OGLE PETROLEUM INC.

RE: Bison Basin Project
Docket No. 40-8745
Source Material Lic. SUA-1396

SUBJECT: Minor Environmental Amendment Request
pertaining to Leak Detection System
for Evaporation Ponds

**LEAK DETECTION SYSTEM
DESIGN**

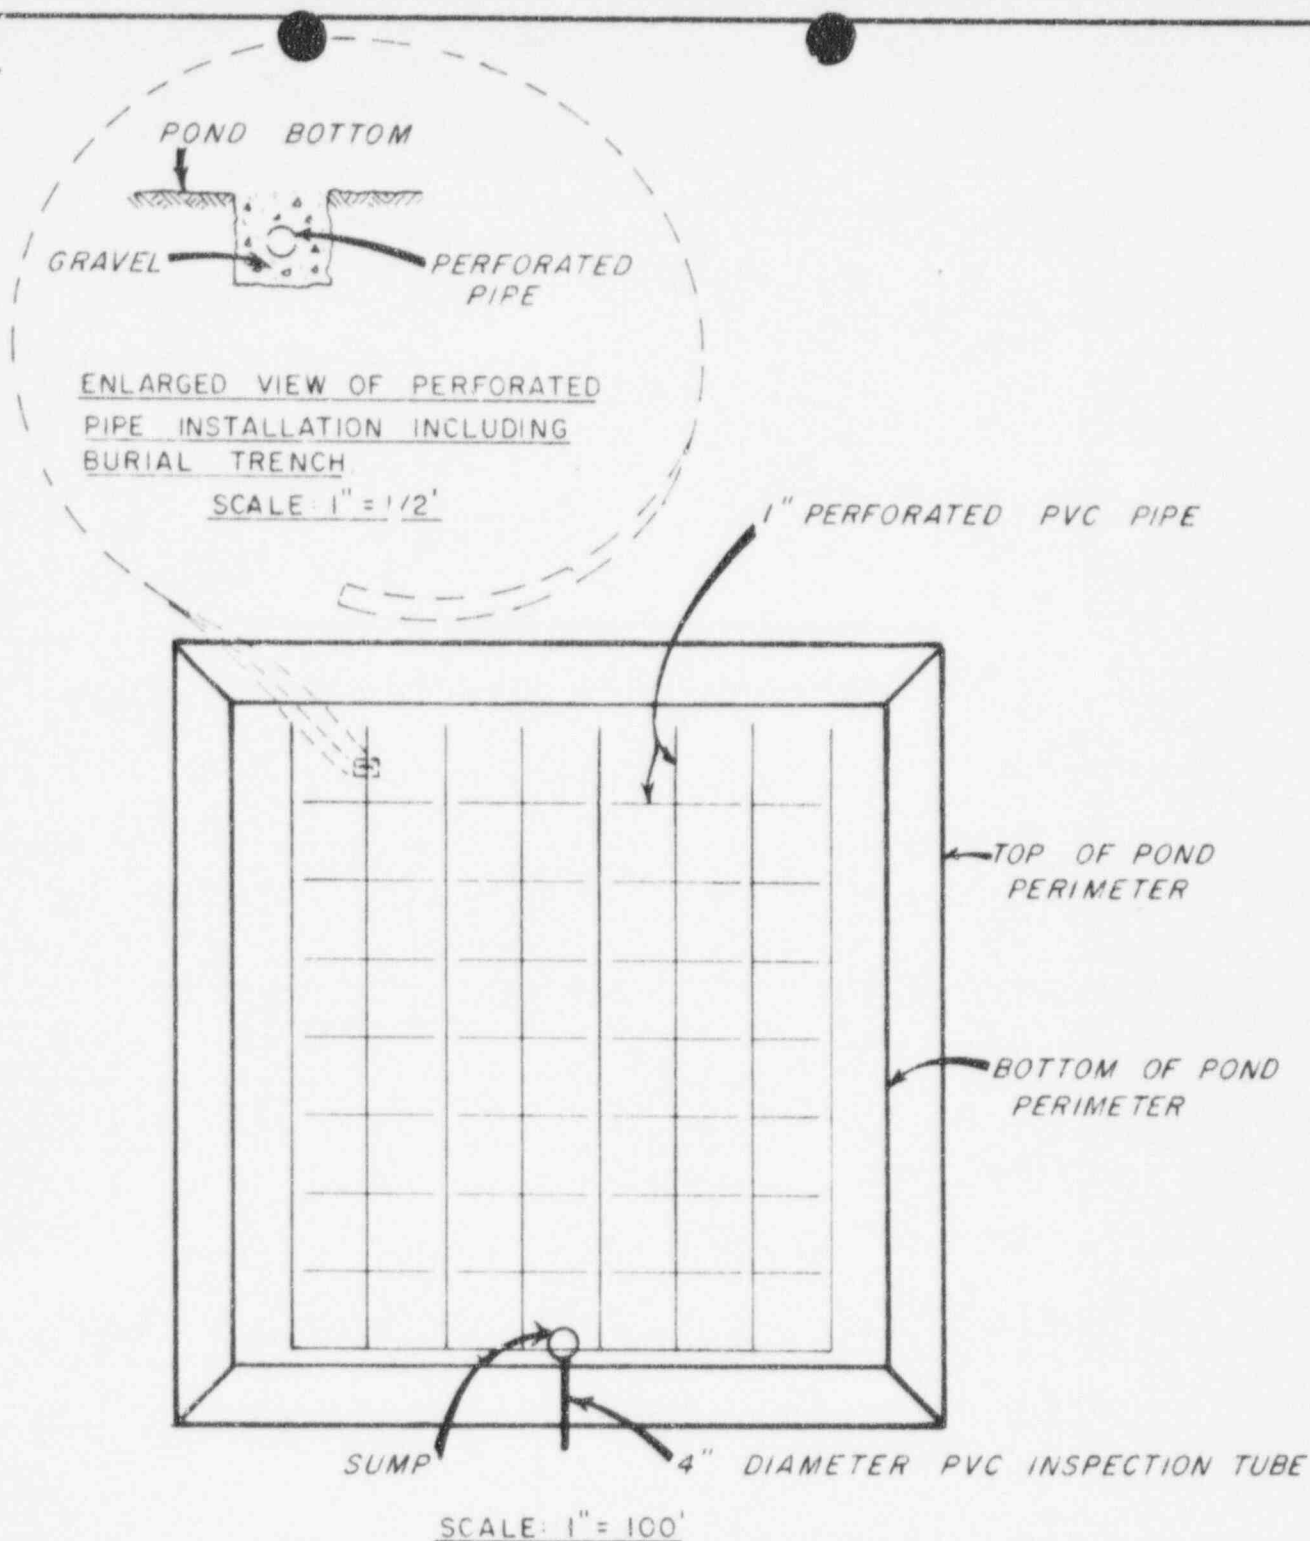
In order to achieve the above stated objectives. OPI proposes the following modification to the leak detection system. A check in the amount of \$760 to cover the minor environmental request fee is enclosed. First, the 3 rows of 4" perforated PVC piping spread approximately 120 feet apart would be replaced by 1" perforated pipe in a grid pattern using 40 feet spacing (see enclosed drawing). Under the old arrangement, leaking pond water could have to travel 60 feet (or even as much as 240 feet for a small leak that travelled down gradient and did not spread out). Under the new proposal, leaking water would only have to travel a maximum of 20 feet before reaching a perforated collection pipe. Second, the 1" perforated pipe would be placed in a small, shallow approximately 3" by 3" trench and surrounded by properly sized gravel that would keep the perforations in the pipe from becoming clogged with fine sands and silt (see enclosed drawing). The shallow trench would act as a mini-sump collecting leaking water from the pond and insuring that it enters the perforated pipe. The hypalon liner would then be placed over the pond bottom. Visual inspection of the soil in the bottom of OPI's first commercial pond on August 4, 1981 (Mr. Dan Gillen of your staff was present) indicated that there was sufficient clay in the soil to provide the relative low permeability needed for the leak detection system proposed above to work.

The above values of permeability are of such a low relative value (clayrange) that it is reasonable to assume that the modification to the leak detection system proposed in this letter would function satisfactorily. OPI would of course still perform (and must pass) the test of the leak detection system specified in item 11 of the QA program.

- 1) POND BOTTOM SLOPES TOWARDS SUMP.
- 2) GRID SPACING OF PERFORATED PIPE IS 40' X 40'.
